The Ohio Valley Coal Company
ARP R-360-70
Environmental Specialist Review
R. Scott Stiteler
9-21-2010
Revised 11-19-10

THE OHIO VALLEY COAL COMPANY
POWHATAN NO. 6 MINE
PERMIT D-0360
ADDENDUM TO SUBSIDENCE CONTROL – PROTECTION OF SPECIFIC
STRUCTURES

RE: Modification to 6/8/2010 Report

Assessment of Subsidence Influences and Recommended Mitigation Measures for FAA Belmont Station, Belmont, OH

Fig. 5 Layout of the Control Building and Recommended Mitigation Measures

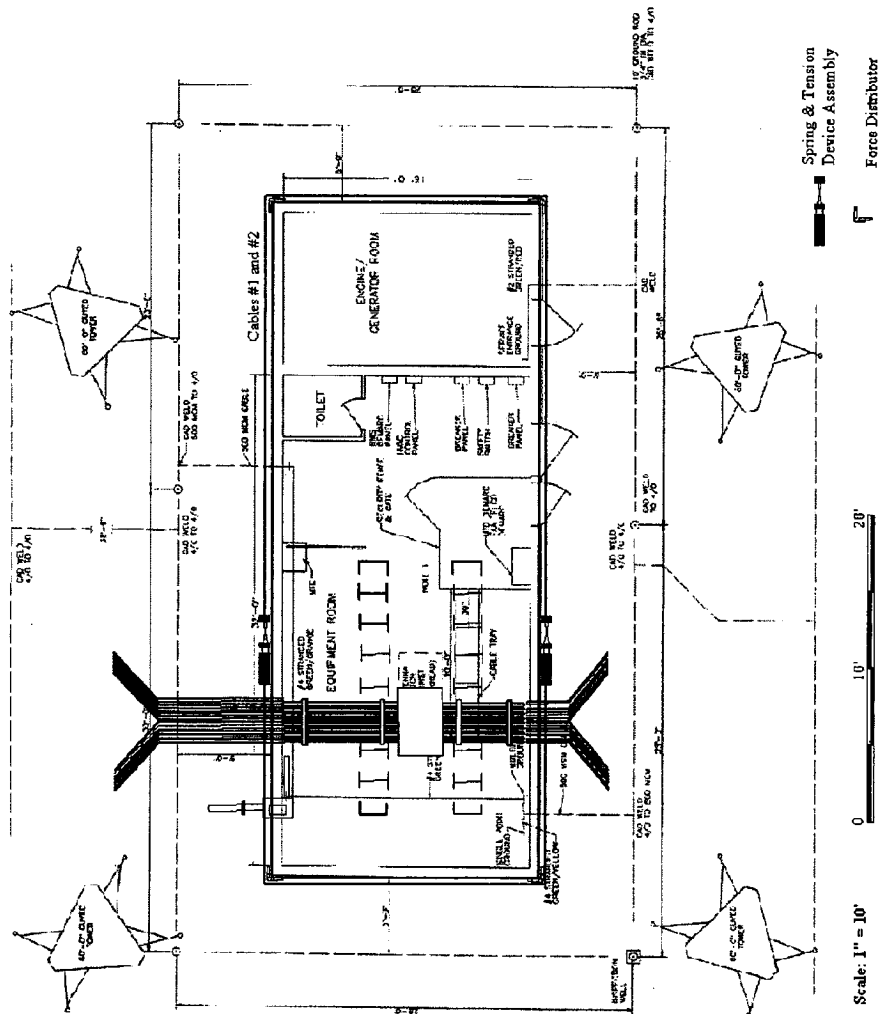
Item 3 (Dr. Lou's report) They did indicate on the subsidence control plan (attached) that Dr. Lou's report was revised to account for the correct building construction of concrete block. The revised addendum says it is attached but it was not.

Dr. Luo revised his mitigation plan upon learning that the control building at the RCAG site was of different construction. Attached is his recommendation for the mitigation for the building and constitutes what will be done in addition to the recommendations in the original report.

In the report, the super-structure of the control building was mistakenly recognized as a simple wood-frame structure. However, it was later discovered that the walls of the superstructure are built with concrete blocks and covered with siding. Due to the heavier weight of the wall structure than wood-frame structure, it is recommended to wrap the walls with one steel cable at a level about two feet below the gutter line. In order for the tension cable method to be more effective, the siding at the building corners at the cable level should be removed. Wood bracing should be inserted between the tension cable and the wall corners. The cable should be tensioned to 2.5 tons (5,000 lbs) during its service life. The cable can be removed and siding reattached after the longwall face has past the control building a distance of 600 ft.
